FOR: HVAC Replacement
FFA Leadership Center Recreation Hall
Kentucky Department of Education
Hardinsburg, Kentucky

ADDENDUM NO. One (1)

ADDENDUM NO. 1

TO: All Plan Holders
FROM: Studio Kremer Architects
PROJECT: Future Farmers of America Leadership Camp
RECREATION BUILDING
ska# 2023-33.7

2 FIRST FLOOR PLAN - LIGHTING
SCALE: 1/8" = 1'-0"

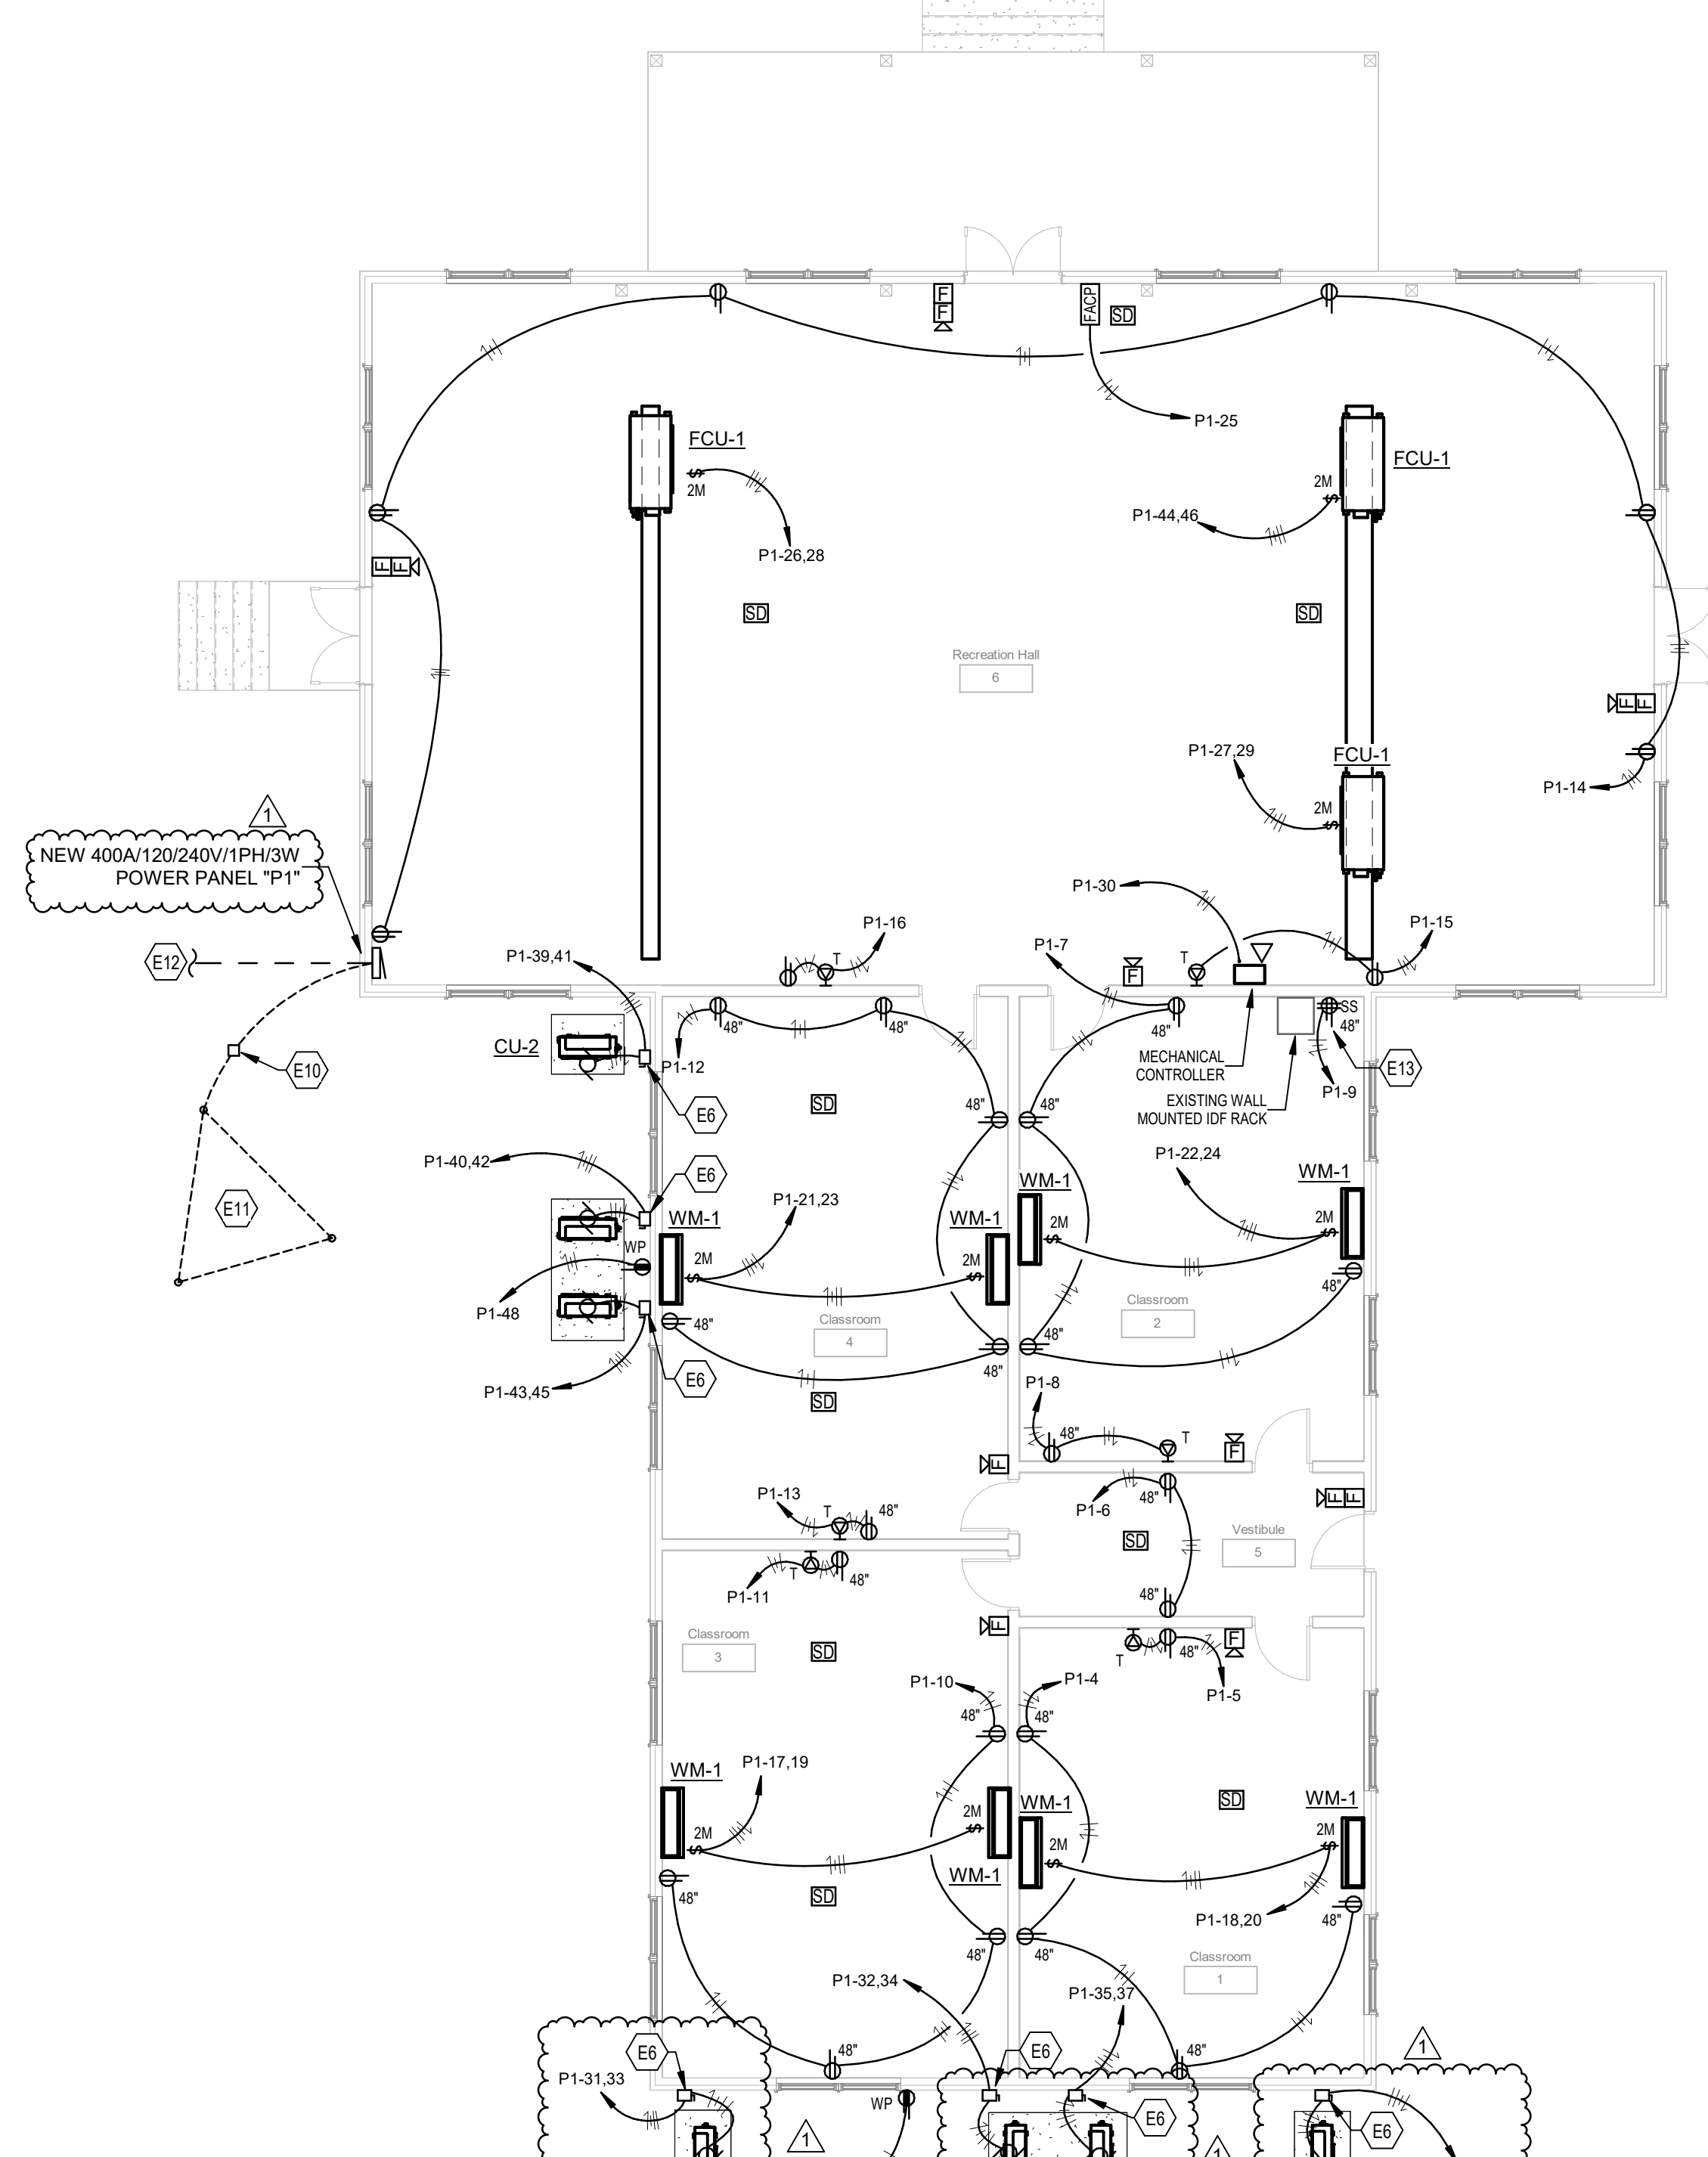
Sheet #	Sheet Title	Noted Update
E200	First Floor Plans - Electrical	Updated lighting design Updated power distribution to condensing units
E300	Electrical Details	Updated electrical keynotes
E301	Electrical Details	Updated power keynotes

Sheet E-200

First Floor Plan – Electrical Demo

First Floor Plan – Lighting & Power/Systems

CMTA Response: All existing romex shall be demoed complete.

CMTA Response: Lighting, power, and fire alarm cabling/conductors shall be in conduit.

CMTA Response: Yes, the new panelboard shall be located in similar location.

CMTA Response: MC cable is acceptable above hard wood ceiling only. New mechanical branch circuits shall remain in EMT conduit above hard wood ceiling.

CMTA Response: MC cable rated for fire alarm use is acceptable above ceiling.

CMTA Response: Fire alarm devices are acceptable to be surface mounted. New electrical devices shall utilize existing pathway where possible, any location where this is not possible surface mounted conduit is acceptable with approval of the owner or engineer.
